The Sizewell C Project

5.1 Consultation Report Appendices G.1 - G.8 Part G: Other Appendices

SCOPING OPINION
Proposed Sizewell C Nuclear Development

This is the Scoping Opinion (the Opinion) provided by the Secretary of State in respect of the content of the Environmental Statement for Sizewell C Proposed Nuclear Development, Near Leiston in Suffolk.

Figure 1

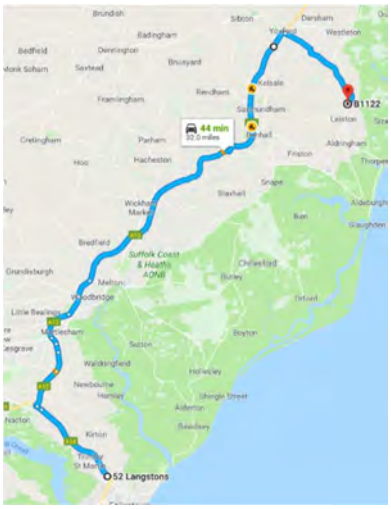
Moreover, it comes at the end of a tortuous 30-mile journey (Figure 1), from either of proposed Freight Management Facilities, on or adjacent to the A14 east of the A12 junction.

Map of Marlesford Area Showing SP&R, A12, and Access Roads

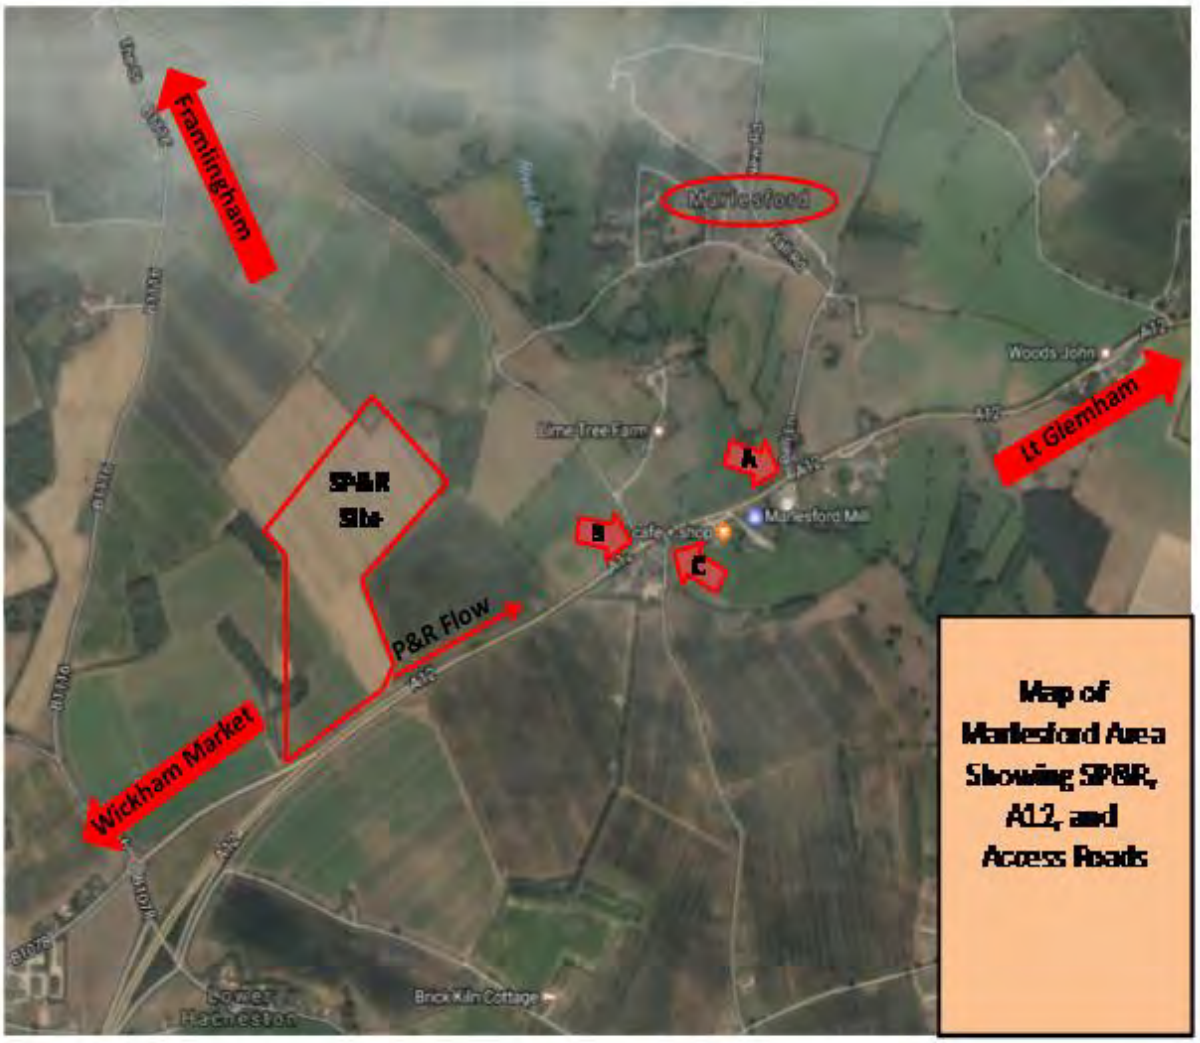
What alternatives are there?	The obvious solution to the traffic concerns mentioned here – A12 access, noise, air pollution – is the often-promised and long-awaited 'four-village bypass'. This would direct all Sizewell-bound traffic onto the bypass before reaching Marlesford and all the concerns expressed here would disappear. Even the present situation would be greatly improved. This is clearly our preferred option. To reduce the use of *rat-runs,* persuading SatNav providers to classify Marlesford Road and Ford Road as *access only* would reduce casual use of these single-track lanes by non-residents. If the bypass does not happen, and the SP&R does, then it may be necessary to install traffic lights in Marlesford, or at the exit of the SP&R. One set of lights, sensor-activated, at the intersection of Marlesford Road (B) and the A12 might suffice. Of course, while this would reduce the A12-access problem, it would have no effect on the noise and air pollution. A quieter road surfacing material would help with the noise, and this has been promised by SCC "next time the road is resurfaced". Only advancing technology seems likely to reduce the air pollution from the passing vehicles, especially the HGVs. Experience shows that, despite instructions to use the A14/A12 route to Marlesford, nearly all HGV's coming from the South and West cut across country, using B roads (e.g. B1116 and B1078). This is because the drivers are mainly subcontracted to deliver the goods and are often owner- drivers. When questioned why they did not follow instructions they deny that the instructions were passed to them and so just followed the shortest SatNav route. We need number-plate recognition equipment at the A14/A12 junction to check HGV's have come via that route.

Figure 1 - Map showing Proposed alternative Route

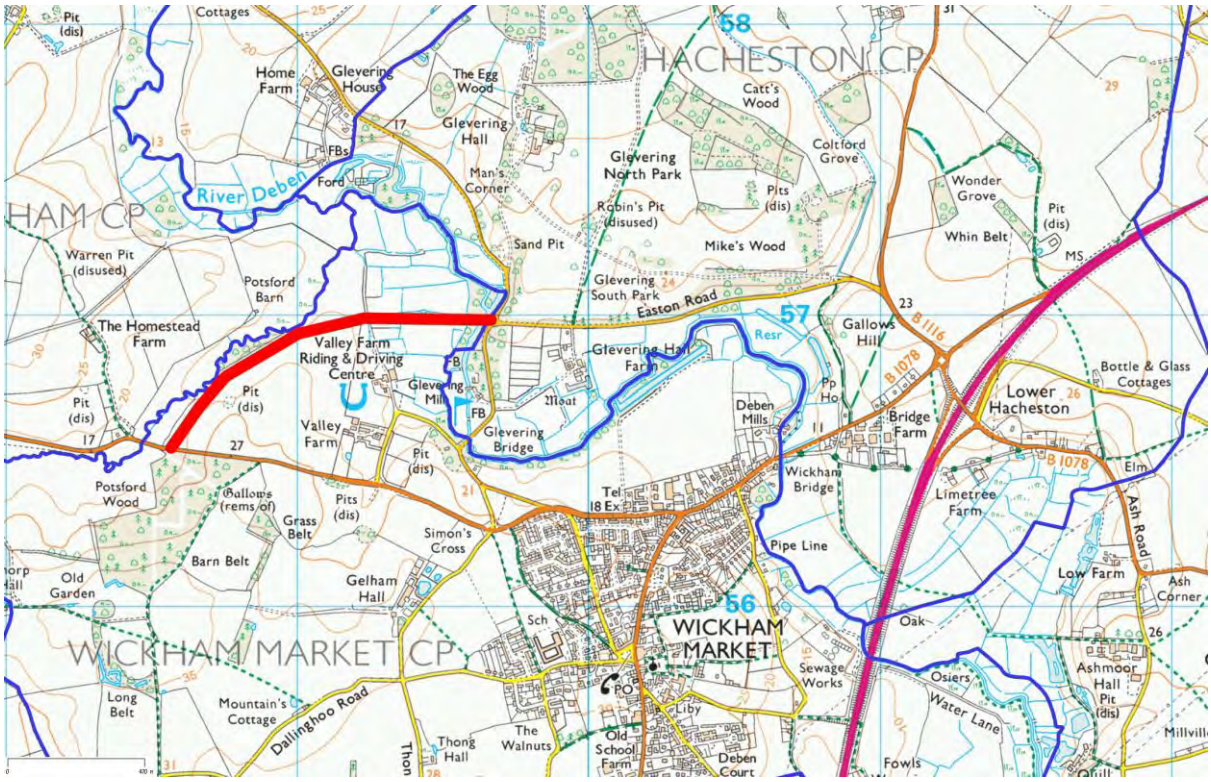
18.10. A possible alternative new road is shown in red below:

This alternative has the significant benefit that road users will choose this route in preference to the existing road route as it will be quicker, a better road and an easier journey. The bridge/crossing over the River Deben will not be easy as it is on a flood plain however, once built it will form an extremely positive lasting legacy for Wickham Market as it will significantly reduce current HGV traffic through the north end of Wickham Market. It is appreciated that this option is not ideal from an environmental perspective and certainly does not have universal support within the Parish Council so if EDF could propose a better diversion route then that would be ideal. Alternatively, if there are significant environmental objections, the diversion route could be temporary, thus the river valley would be returned to its natural state after the project.
